# Access Compliance Report

## Public Rights-of-Way

### (Curb Ramps)

Intersection ID: 10071	Main Street: E_36TH_ST	Cross Street: YADKIN_AV	Location: S
ADA ID: 56389B0514FA	Ramp Type: PerpDiag	Initial Pass/Fail: Fail	Overall Compliance: No
			Severity Score: 33.75

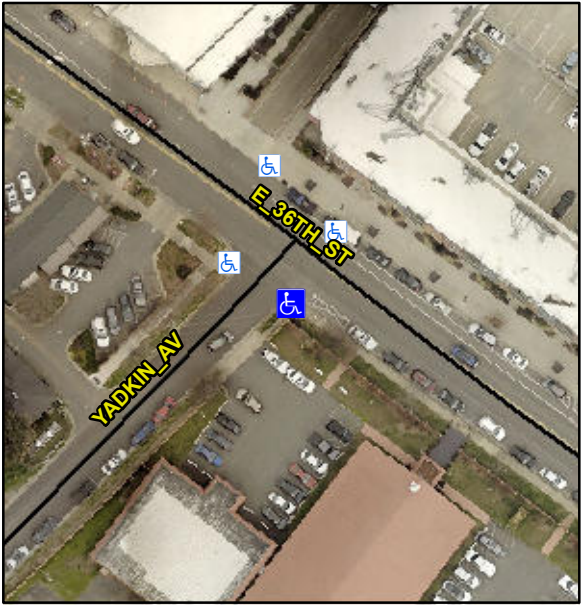
Codes/Mitigation Info/Possible Solution			Field Measurements/Component Compliance		
	Possible Solutions:		<b>Compliance</b>	<b>Description</b>	<b>Data</b>
	<b>Remove &amp; Replace Curb Ramp With Two New Directional Ramps or Equivalent.</b>		<b>No</b>	Ramp Length (in)	<b>57.5</b>
			<b>No</b>	Ramp Width (in)	<b>47.5</b>
			<b>N/A</b>	Flare Type LT	<b>N/A</b>
			<b>N/A</b>	Flare Slope LT (%)	<b>N/A</b>
			<b>N/A</b>	Flare Traversable LT?	<b>N/A</b>
			<b>N/A</b>	Landing Length (in)	<b>N/A</b>
			<b>N/A</b>	Landing Width (in)	<b>N/A</b>
			<b>N/A</b>	Landing Slope (%)	<b>N/A</b>
			<b>N/A</b>	Landing X Slope (%)	<b>N/A</b>
<p>Surveyor Notes:</p> <p><b>N/A</b></p> <p>PROW/ADA:</p> <p><b>Not Found, R304.5.1, R304.2.2, R304.5.3</b></p>			<b>N/A</b>	Flare Type RT	<b>N/A</b>
			<b>N/A</b>	Flare Slope RT (%)	<b>N/A</b>
			<b>N/A</b>	Flare Traversable RT?	<b>N/A</b>
			<b>N/A</b>	DWS Provided?	<b>N/A</b>
			<b>N/A</b>	DWS Contrast?	<b>N/A</b>

<b>N/A</b>	DWS Length (in)	<b>N/A</b>
			<b>N/A</b>	DWS Full Width?	<b>N/A</b>
			<b>N/A</b>	DWS Offset (in)	<b>N/A</b>
			<b>N/A</b>	Gutter Slope (%)	<b>N/A</b>
			<b>N/A</b>	Gutter X Slope (%)	<b>N/A</b>
			<b>No</b>	Painted X Walk1?	<b>Yes</b>
				X Walk 1 Direction	<b>To NE</b>
			<b>N/A</b>	X Walk 1 Width (in)	<b>N/A</b>
			<b>4.2</b>	X Walk 1 Slope (%)	<b>2.5</b>
			<b>0.4</b>	X Walk 1 X Slope (%)	<b>0.1</b>
			<b>N/A</b>	Ramp inside XWalk1?	<b>Yes</b>
			<b>1.1</b>	Road Slope (%)	<b>N/A</b>
			<b>3.2</b>	Road X Slope (%)	<b>N/A</b>
			<b>N/A</b>	Any Obstructions?	<b>N/A</b>
				Obstruction Type	
Total Cost: \$ 3200.00			<b>N/A</b>	Storm Grate/Utility Hazard?	<b>N/A</b>
			<b>N/A</b>	Storm Grate/Utility Type	
			<b>Yes</b>	Surface Condition? (G/P)	<b>Good</b>
